The Cutaway — Architectural Design Response
iNSW — Rev G — 31/08/23

Project Name	The Cutaway		
Project Code	BCY		
Revision	Date	Comment	Approved
0	31/05/23	Draft Issue	EC
A	06/06/23	Issue for Review	EC
B	07/06/23	Final Issue	EC
C	14/06/23	Final Issue	EC
D	26/06/23	Final Issue	EC
E	21/07/23	Reissue for DPE	EC
F	27/07/23	Reissue for DPE	EC
G	31/08/23	Reissue for DPE	EC
H	08/09/23	Reissue for DPE	EC

Elevation

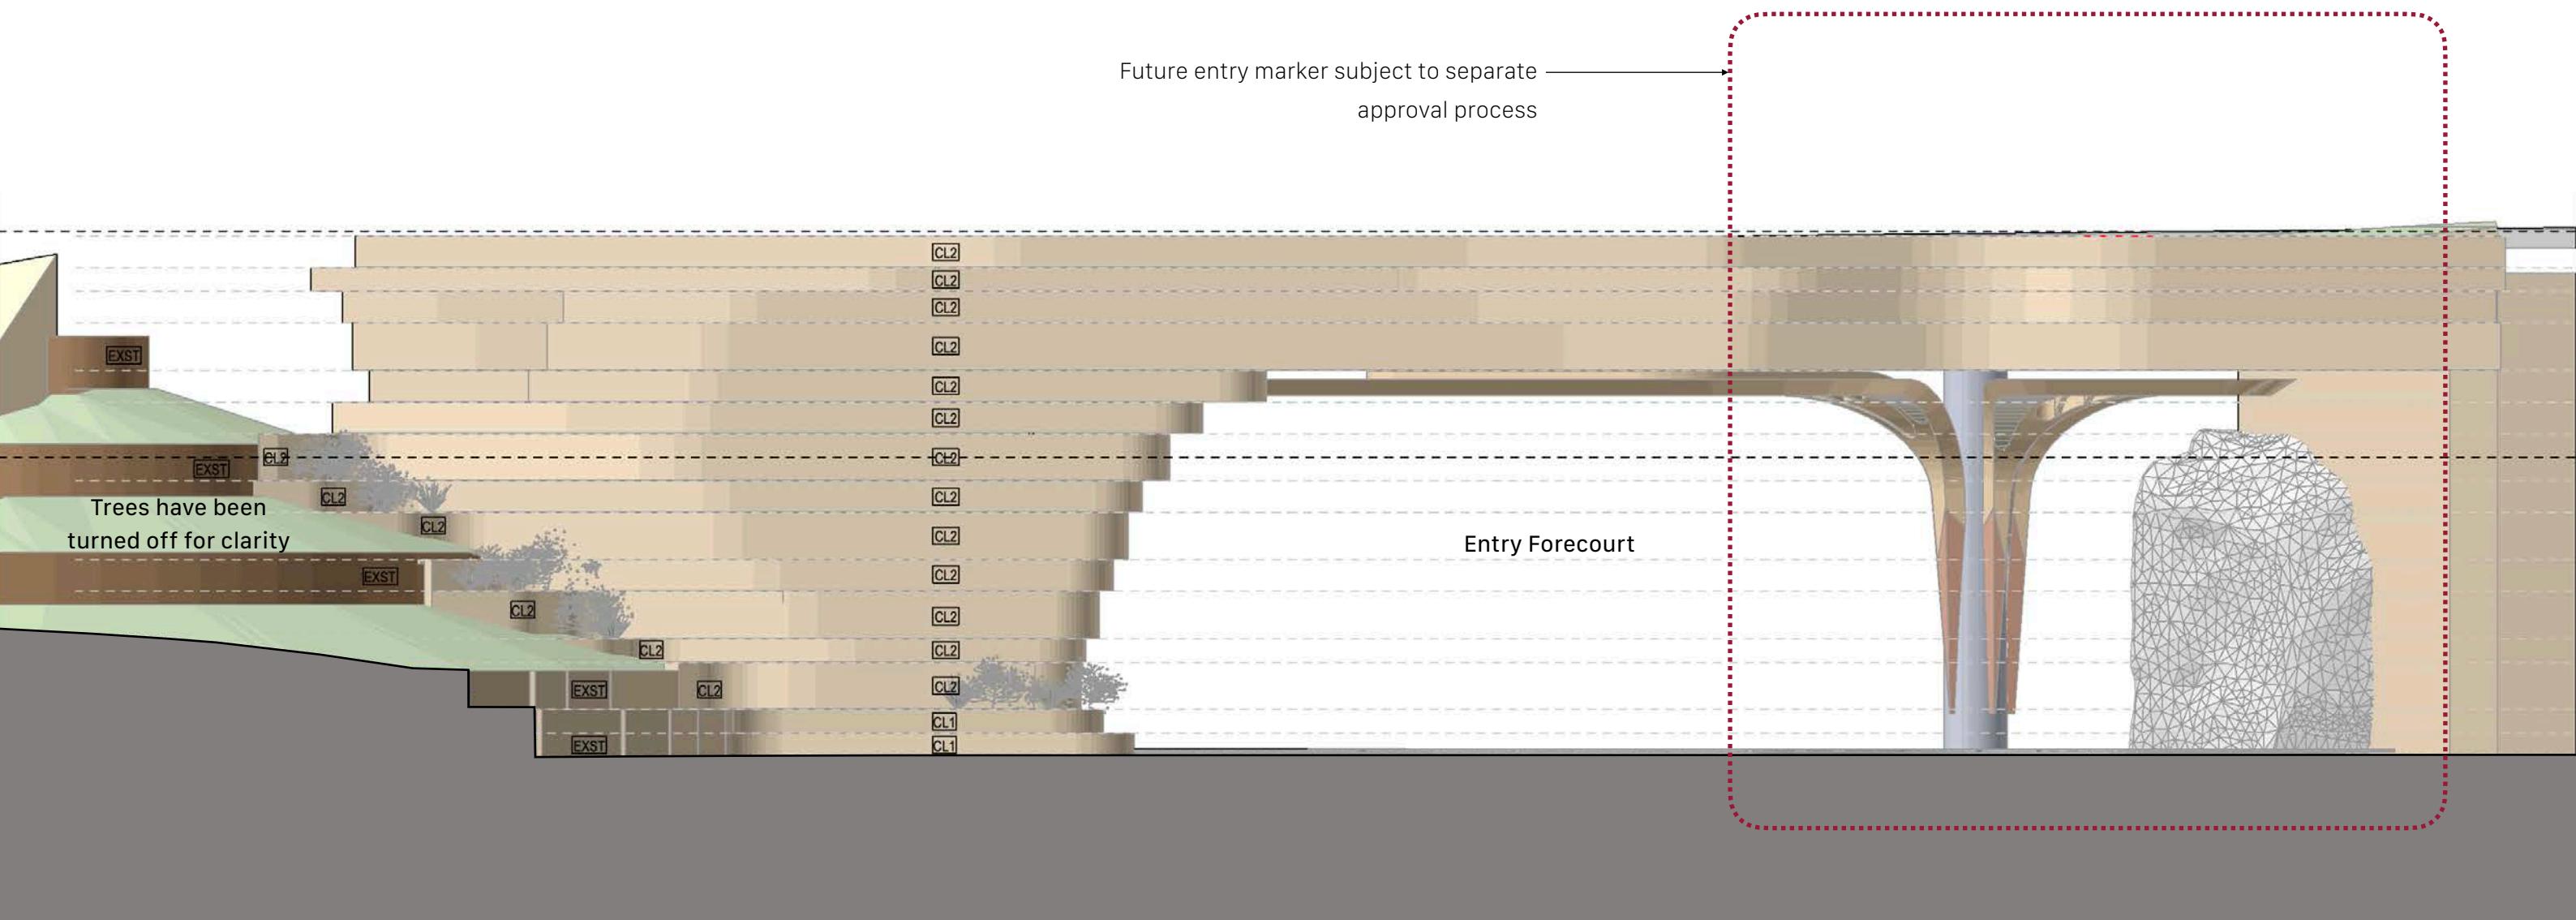
b. indicate which elements are sandstone and which are masonry — detail colours and finishes of all materials

Provide elevation plan/s that show the entry area to the Cutaway and associated landscaping.

CL1 — sandstone cladding

CL2 — GRC cladding, sandstone coloured

Sydney Metro Coordination

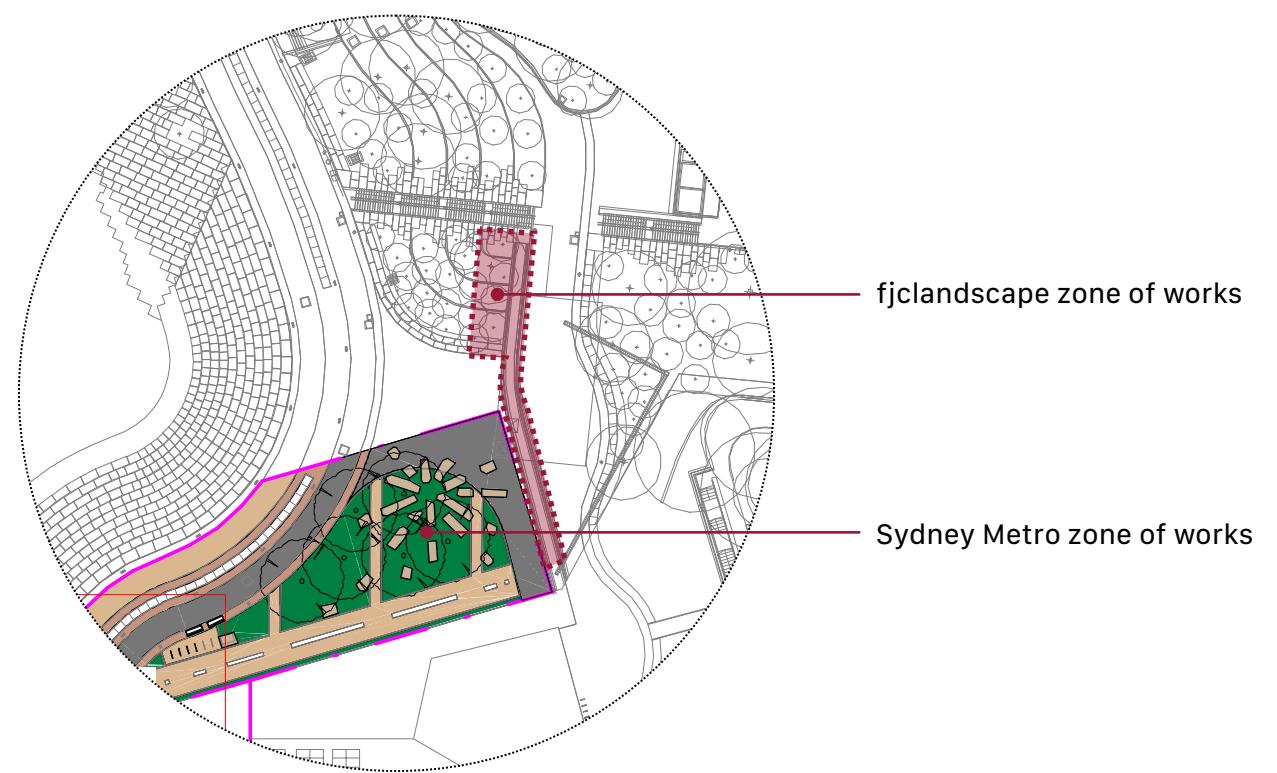
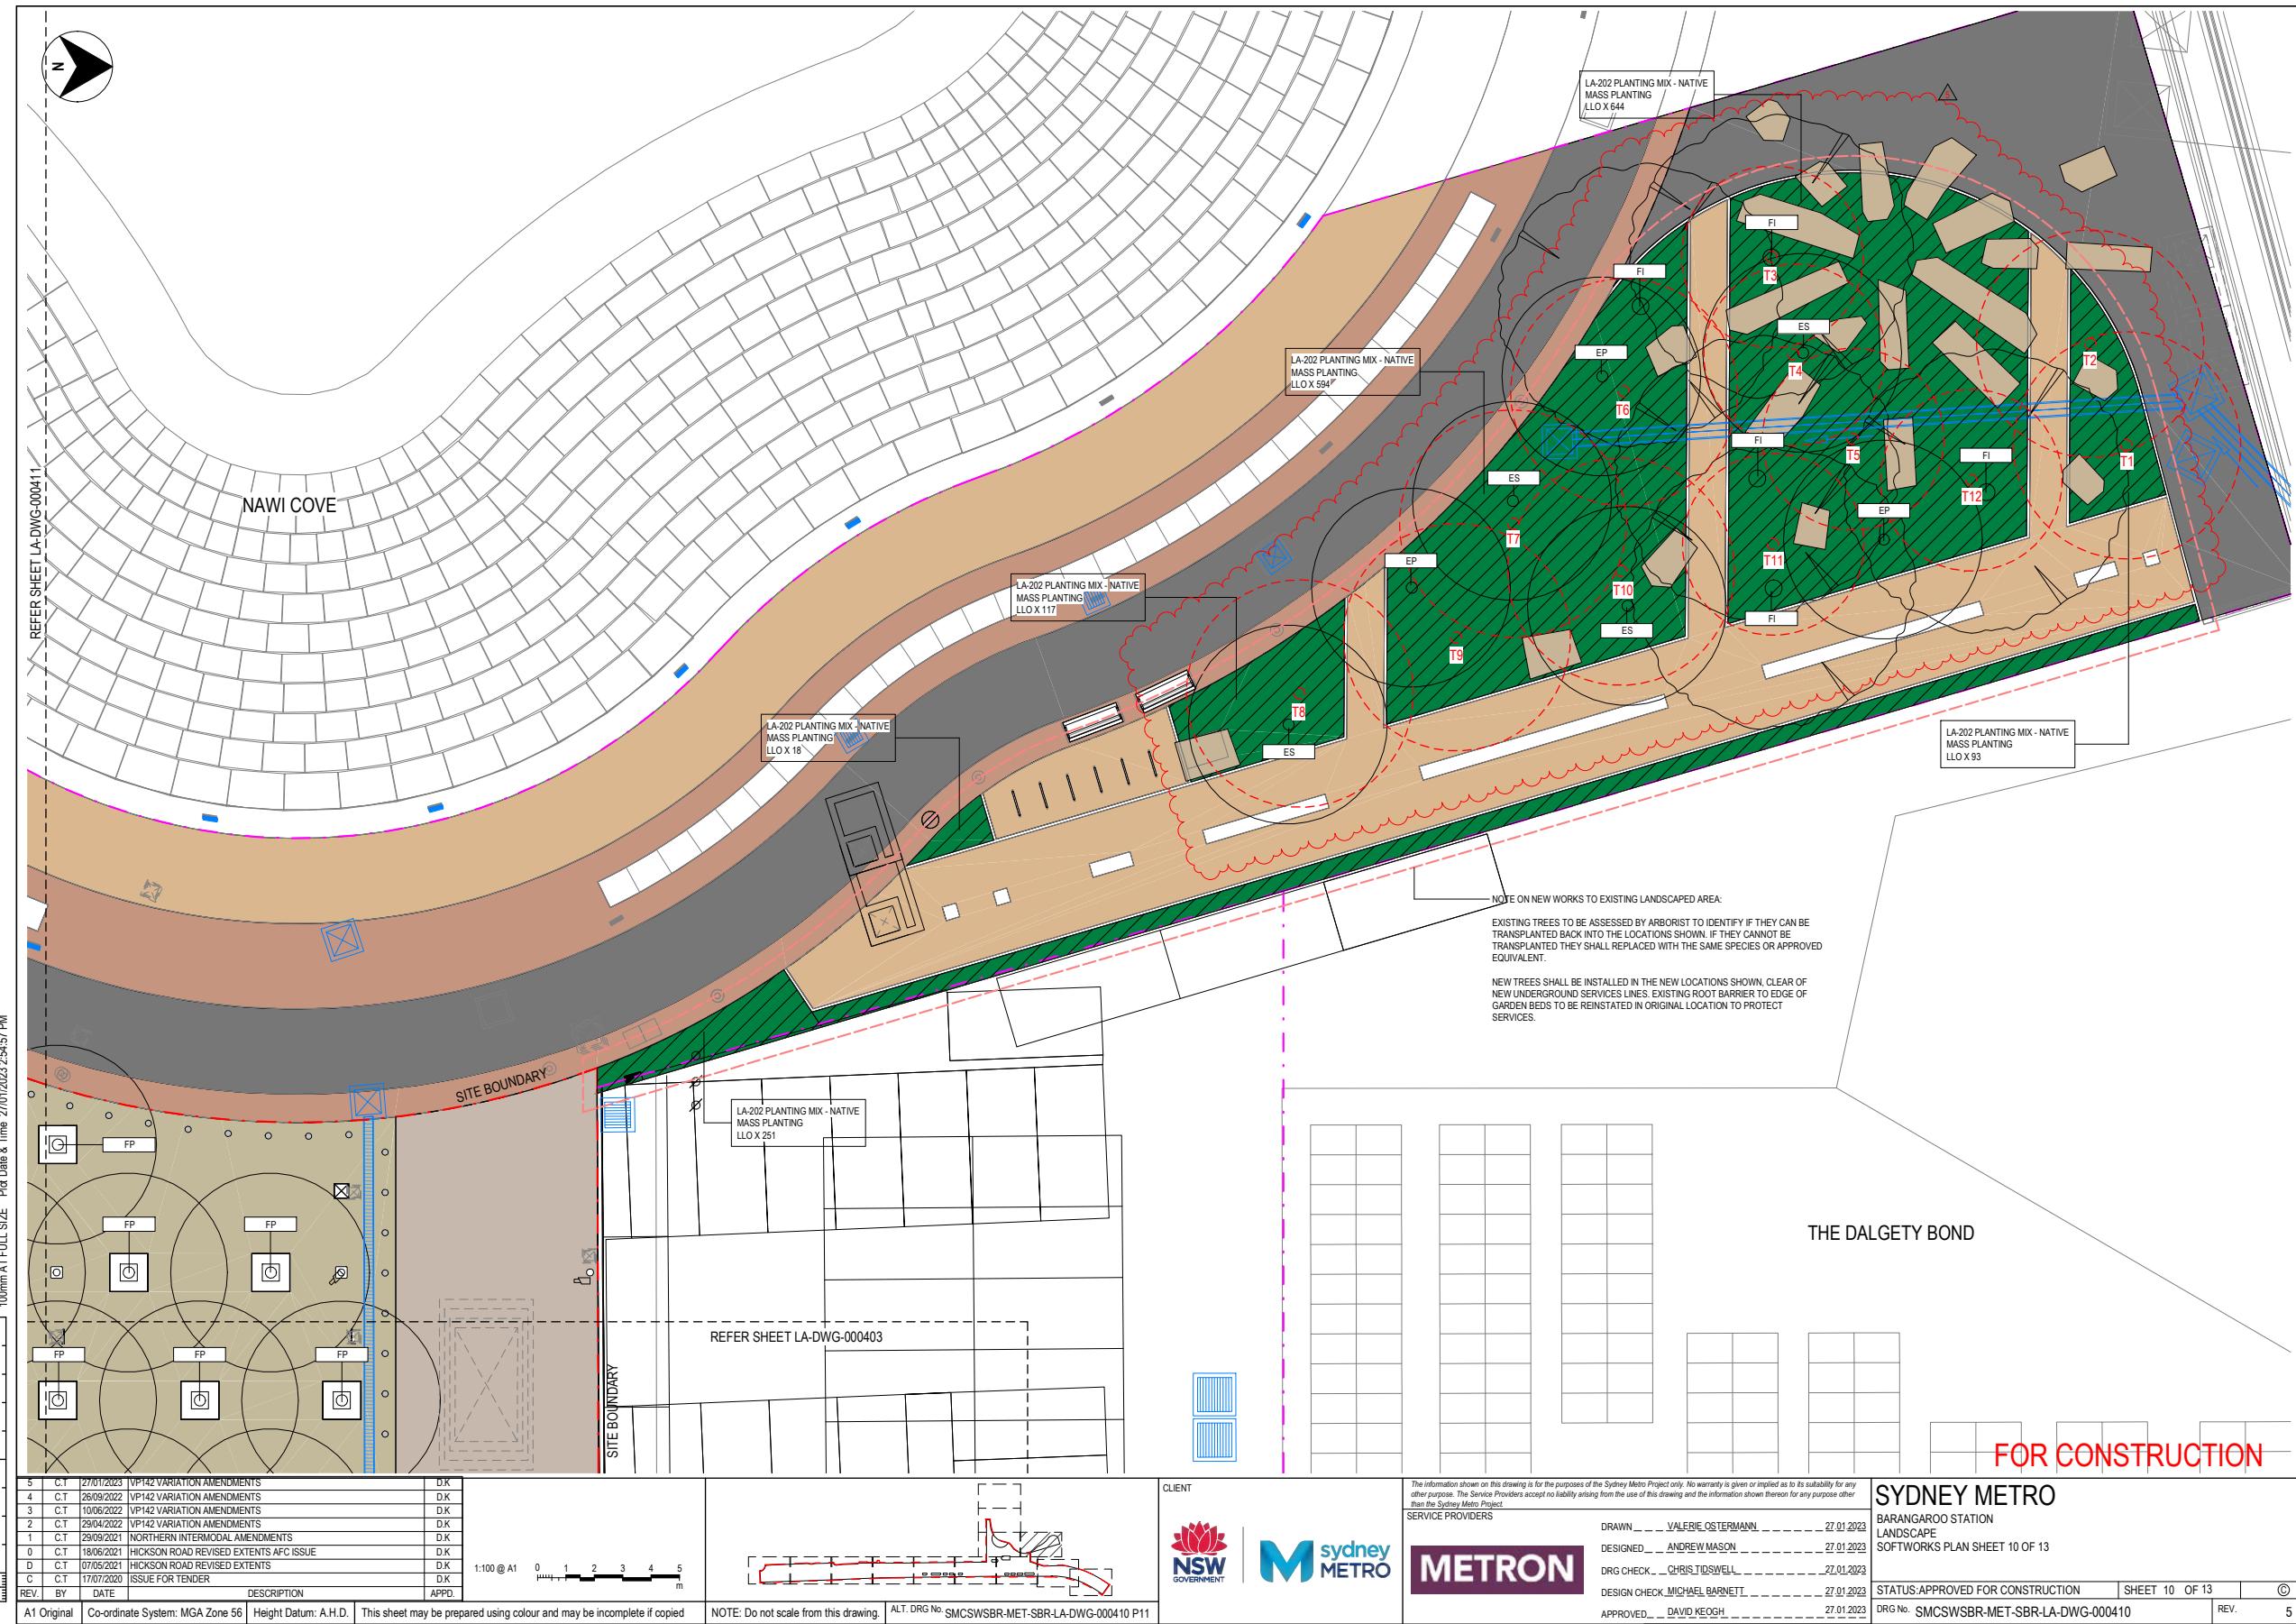
Demonstrate how landscaping at the entrance of the Cutaway will integrate with the Sydney Metro site, including evidence of consultation with Sydney Metro.

Consider the ability for planted tree/s to replace the sculptural timber elements at the entrance to the Cutaway.

On the 24th of May, 2023 the fjcstudio team met with Sydney Metro to discuss and coordinate the interface between the two projects.

Following this, Sydney Metro have advised the following with regard to the existing trees adjacent the Cutaway entry:

- Whilst the reinstated trees match the quantity and species of the original plantings, they will not be going back into the original pre-Metro locations:
- We placed the reinstated trees following discussions with both the Sydney Metro civil design team (Joe Heydon) and the NSW arborist (Stuart Pittendrigh)
 - Civil: we identified that there will be reduced soil depth at the northern end due to new chilled water pipe
 - Arborist: we understood that they believed that the original northern-most trees were not performing well due to overshadowing from the Headland Park / Cutaway

As per the above, it is not recommended to reinstate 'real trees' close to the Cutaway entry. Please refer to the planting plan on the following page as received from the Sydney Metro team.

Entry Timber

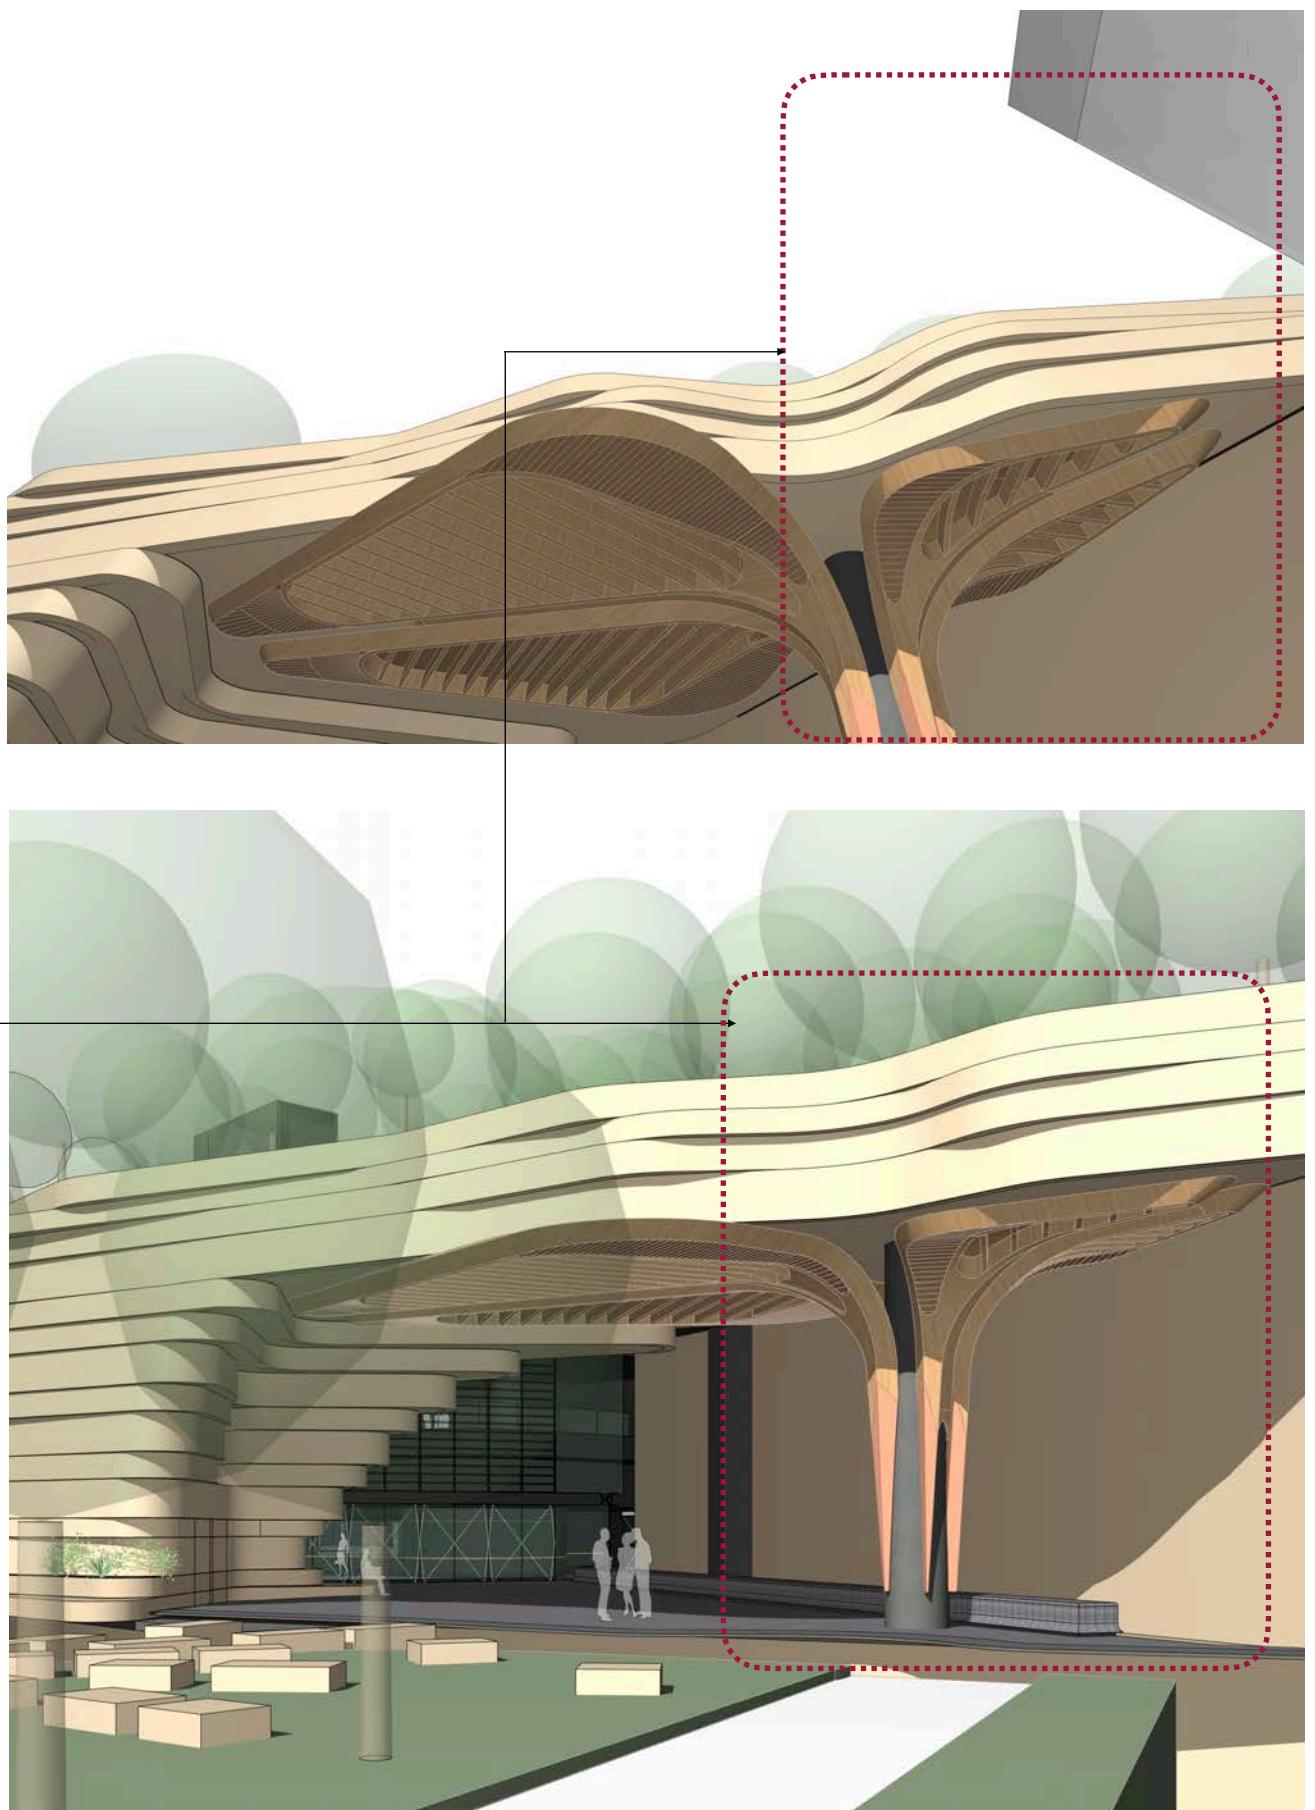
Regarding the 'marker' tree structures at the entrance, as per the HCT interpretive structure; the materiality and construction of these elements at the Cutaway entrance are not described adequately to be satisfied of the longevity of the proposal and its suitability for exposure to the elements in the public domain. Further detail is required.

We have refined and developed the detailing of the sculptural entry timber. We are using a combination of timbers to highlight various elements of the tree, to address different functions and to concentrate more durable species around the ground plane where it is more susceptible to damage and vandalism.

We have specified timbers which are appropriate and durable for the exposure and climate — this has been worked through with a specialist timber consultant.

The edges have been carefully detailed to ensure water will not sit on the timber. The inclined edge beam also assists with shedding water off the structure.

Engraved words of meaning will be incorporated into the base of the structure, which will be designed in collaboration with Jake Nash.
